Product Change Notification / ASER-27LSS520

CCB 4514 Final Notice: Qualification of MTAI as an additional assembly site for selected MSCC products available in 48L VQFN (7x7x1mm) package.

CCB 4514
Pre and Post Change Summary
PCN #: ASER-27LSS520

Lead frame Comparison

Pre Change

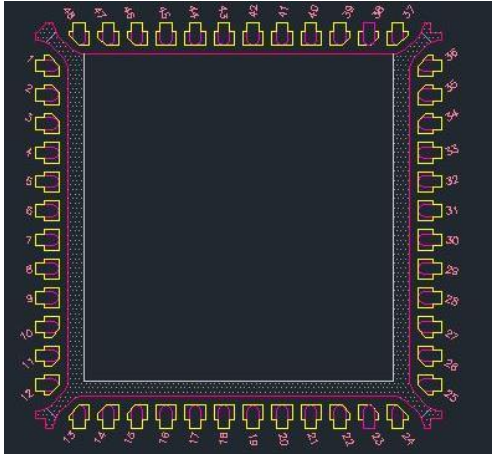
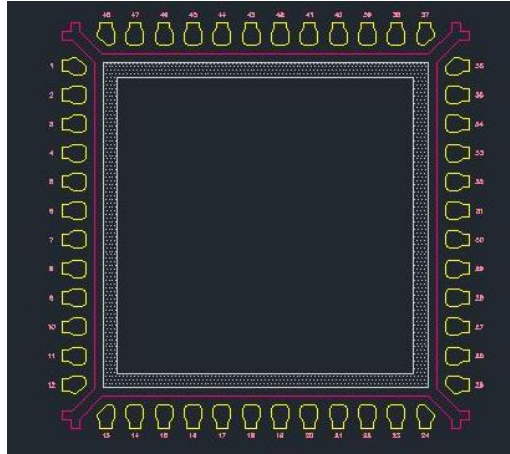
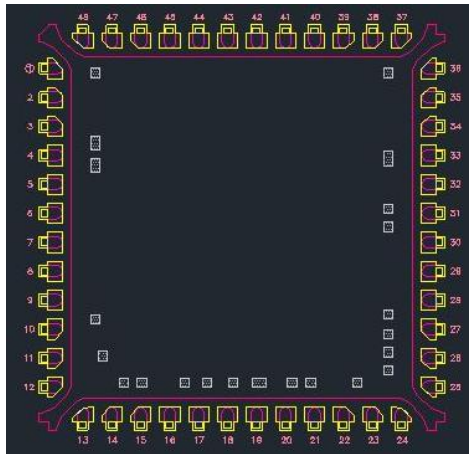
Description of Change: Qualification of MTAI as an additional assembly site for selected MSCC products available in 48L VQFN (7x7x1mm) package.

| | Pre Change | | | Post Change | | | |
|---------------|----------------------------|-------------------------|-------------------------------|----------------------------|-------------------------|-------------------------------|-------------------------------|
| Assembly Site | ASE Group -Malaysia (ASEM) | Unisem Chengdu Co.,Ltd. | Microchip Technology Thailand | ASE Group -Malaysia (ASEM) | Unisem Chengdu Co.,Ltd. | Microchip Technology Thailand | Microchip Technology Thailand |

Post Change

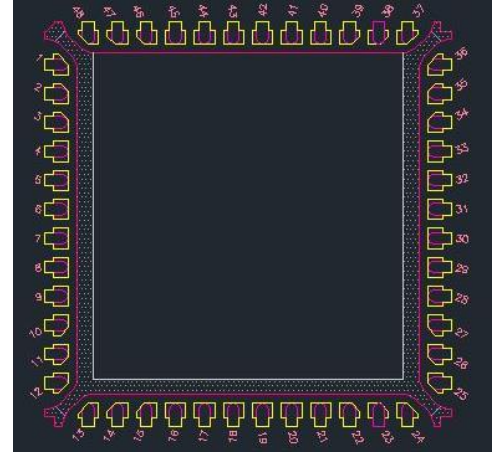
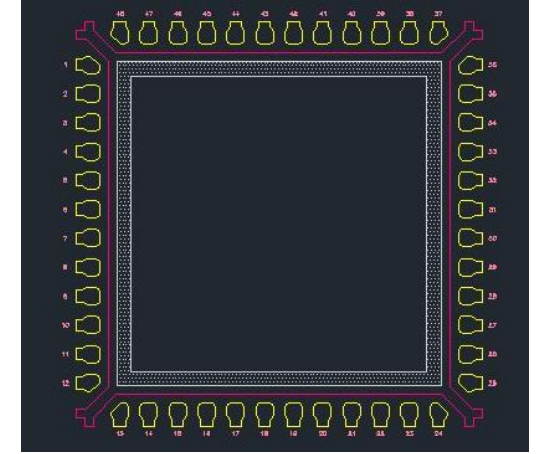
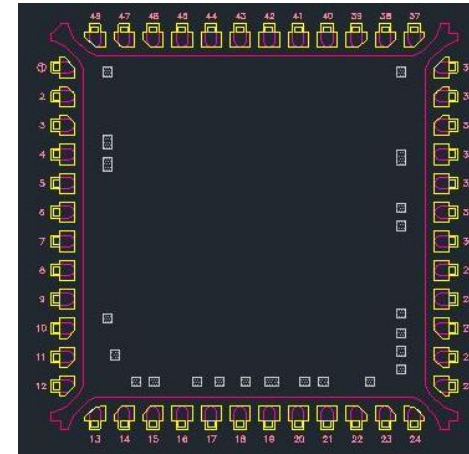
| Lead Frame Lead-lock | No | No | Yes | No | No | Yes | Yes |
